Project	IEEE 802.16 Broadband Wireless Access Working Group < http://ieee802.org/16 >
Title	Terminology Change for H-ARQ MAP
Date Submitted	2004-08-20
Source(s)	Geunhwi Lim, Yong Change, Hong Sung Chang, JungWon Kim, TaeWon Kim Samsung Electronics Co. Ltd. geunhwi.lim@samsung.com
Re:	
Abstract	Terminology Change for H-ARQ MAP
Purpose	Adoption of proposed changes into P802.16d /D5-2004
Notice	This document has been prepared to assist IEEE 802.16. It is offered as a basis for discussion and is not binding on the contributing individual(s) or organization(s). The material in this document is subject to change in form and content after further study. The contributor(s) reserve(s) the right to add, amend or withdraw material contained herein.
Release	The contributor grants a free, irrevocable license to the IEEE to incorporate material contained in this contribution, and any modifications thereof, in the creation of an IEEE Standards publication; to copyright in the IEEE's name any IEEE Standards publication even though it may include portions of this contribution; and at the IEEE's sole discretion to permit others to reproduce in whole or in part the resulting IEEE Standards publicatio

Figure 23—Subchannel allocation modes of Compact DL-MAP IE for Band AMC

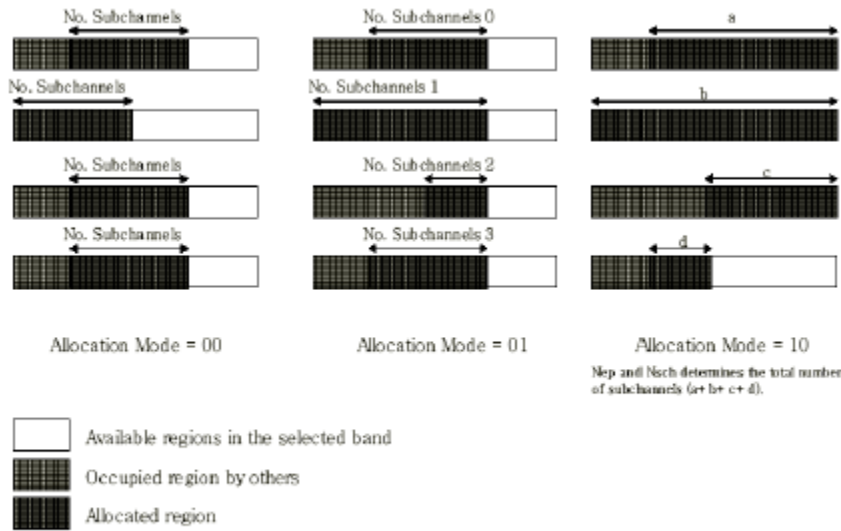
This value indicates the subchannel allocation mode in the selected bands. The value is set to binary 00 when the same numbers of [subchannels slots](#) are allocated in the selected bands by the following field '[No. Subchannels-Duration](#)'. The value is set to 01 when different numbers of [subchannels slots](#) are allocated in each selected bands by the following fields "[No. Subchannels-Duration](#)". The value is set to 10 when the total number of [subchannels slots](#) allocated in the selected bands is defined by *NSCH* code and *NEP* code. The [subchannels slots](#) fill from the bands with lowest index. The allocation mode variant is shown in Figure 23.
